DPC-NE-2005-A

Duke Power Company Thermal-Hydraulic
Statistical Core Design Methodology

SUBJECT: REQUEST FOR ADDITIONAL INFORMATION - APPENDIX D,
"OCONEE PLANT SPECIFIC DATA, MARK-B11 FUEL, APPLICATION OF BWU-Z
CHF CORRELATION TO MARK-B11 MIXING VANE SPACER GRID FUEL
DESIGN," TO DPC-NE-2005P, "DUKE POWER COMPANY THERMAL-
HYDRAULIC STATISTICAL CORE DESIGN METHODOLOGY"
(TAC NOS. 98660, 98661, AND 98662)

Response to NRC Request for Additional Information
on Appendix D to Topical Report DPC-NE-2005-P,
"Duke Power Company Thermal-Hydraulic Statistical
Core Design Methodology"

Figure D-1 - Mark-B11 Vane Data
VIPRE-01 Measured Versus Predicted CHF

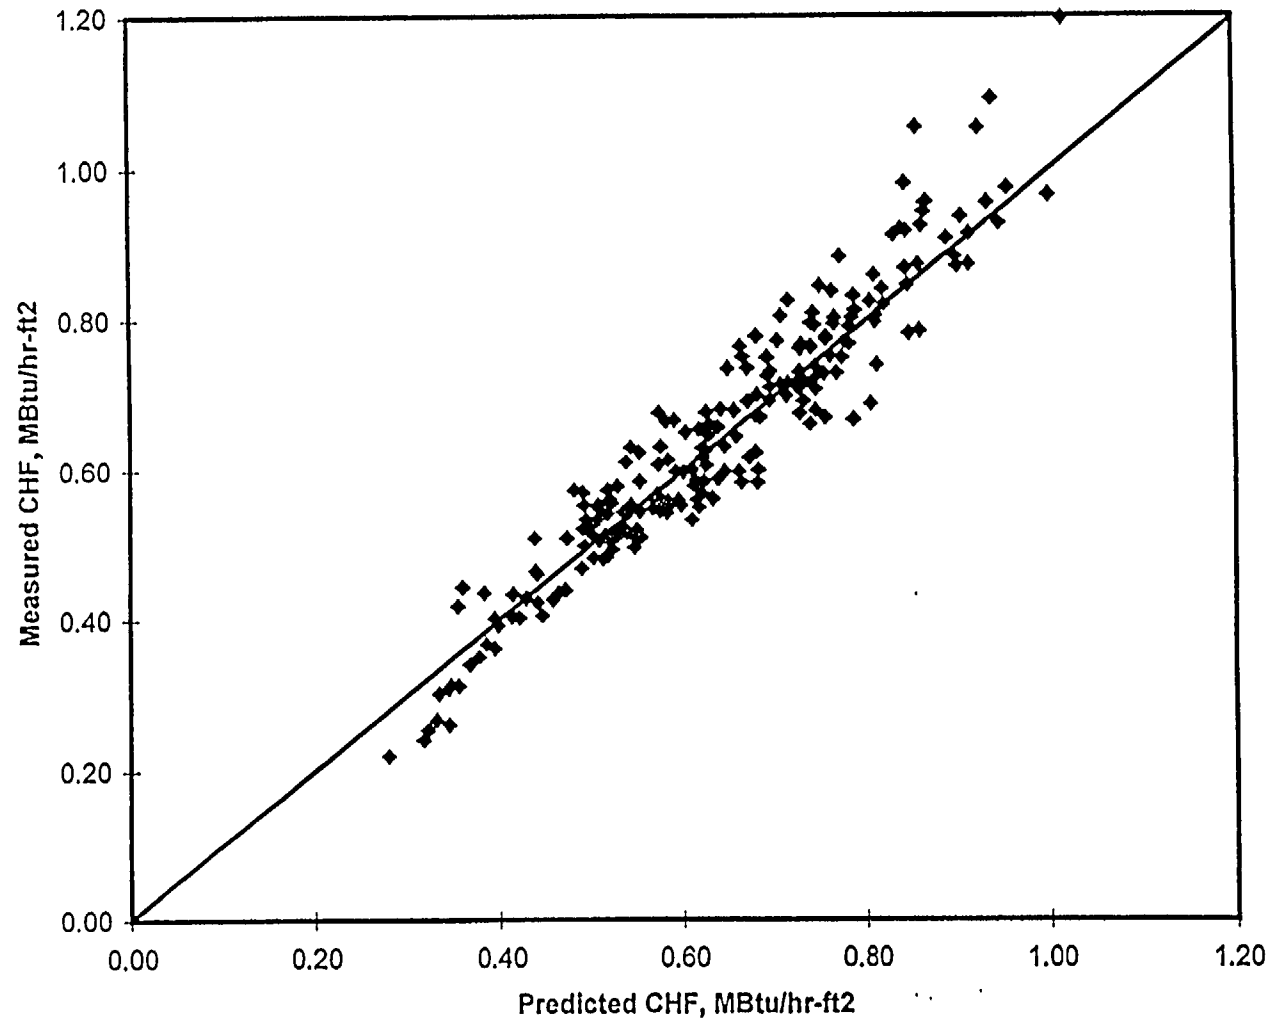
5. *The calculation with the VIPRE-01 code using BWU-Z correlation form for B11 fuel show essentially the same results as those obtained with LYNX over the correlation's database (as documented in Addendum 1 of BAW-10199). However, the BWU-Z correlation as modified for analysis of B11 fuel has not yet been approved by the staff, and the topical report describing this correlation, Addendum 1 of BAW-10199, is still being reviewed. This means that the design limit DNBR for the parameter ranges stated in Table D-2 may not be the final approved value or range of applicability. Specifically, the database for the form of the correlation spans a pressure range of 700 to 2400 psia, not 400 to 2465 psia range stated in Table D-2. Also, the plot in Figure D-3 (see p. D-11) shows a distinct nonconservative bias with decreasing pressure (which is identical to the trend shown for the correlation in the Addendum 1 submittal). There is also a nonconservative bias with the increasing power, clearly shown by plot of measured versus predicted Critical Heat Flux (CHF) in Figure D-1. What would be the effect on the thermal-hydraulic statistical core design analysis for Oconee if the DNBR design limit of the CHF correlation for B11 fuel were to be increased, or if the range of applicability of the correlation were to be limited to pressures of 700 to 2400 psia?*

The pressure range reported in Table D-2 is consistent with the conclusion made in Addendum 1 of BAW-10199. The Addendum 1 conclusion states that the correlation parameter range for the BWU-Z correlation with the Mark-B11V multiplier is the same as the BWU-Z correlation. The data base for the Mark-B11 fuel included a pressure range of 595 psia to 2425 psia as stated in Table E-7 of Addendum 1 to BAW-10199. Also, Figure D-3 shows a slight conservatism with decreasing pressure. Likewise, Figure D-1 shows a slight conservatism with increasing power.
